From: Zheng Hua 郑华(ACPR1000研发项目部) <zhenghua2@cgnpc.com.cn>
Sent: Monday, September 12, 2016 9:09 PM
To: Gallagher, Carol; Kaplan, Michele
Subject: [External_Sender] Dear Sir, is Figure 5 in "Regulatory analysis for the final rule amending 10 CFR Part 171" (ML16054A285) wrong?
Attachments: Figure 5 from ML16054A285 and ZHENG Hua's calculation result.docx

I have read "Regulatory analysis for the final rule amending 10 CFR Part 171" (ML16054A285), and I think Figure 5 in this document is wrong. Please check it.

Figure 5 from ML16054A285

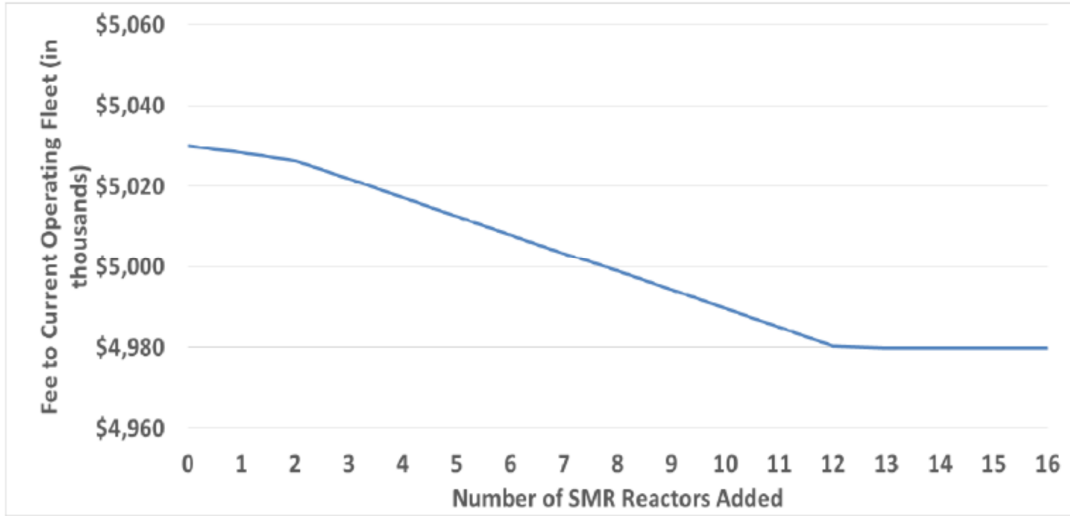
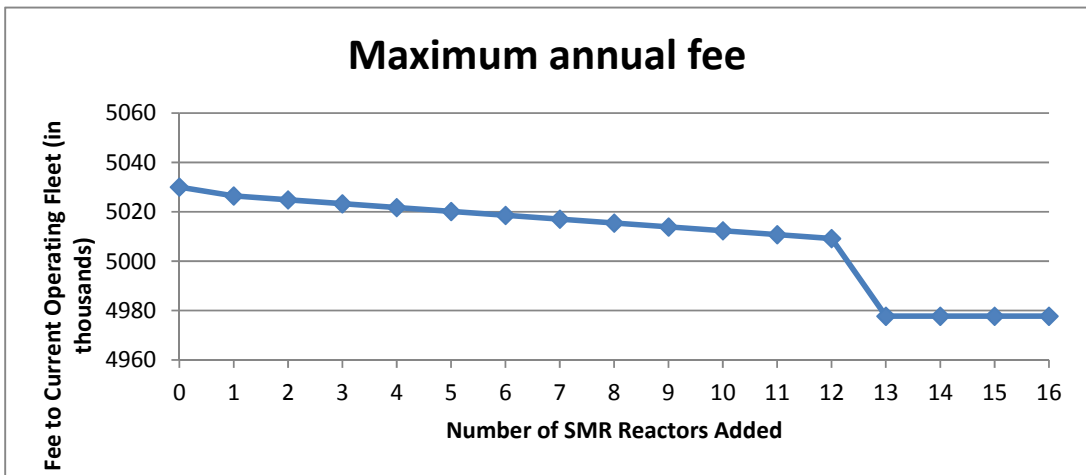
For 12 NuScale modules, the cumulated thermal power is 1920 MWt (160MWt per module), smaller than 2000 MWt, which means for this SMR facility, only minimum annual fee and variable fee is needed; but for 13 NuScale modules, the cumulated thermal power is 2080 MWt, greater than 2000 MWt, which means for this SMR facility, only maximum annual fee is needed and the annual fee for current operating fleet will decrease greatly.
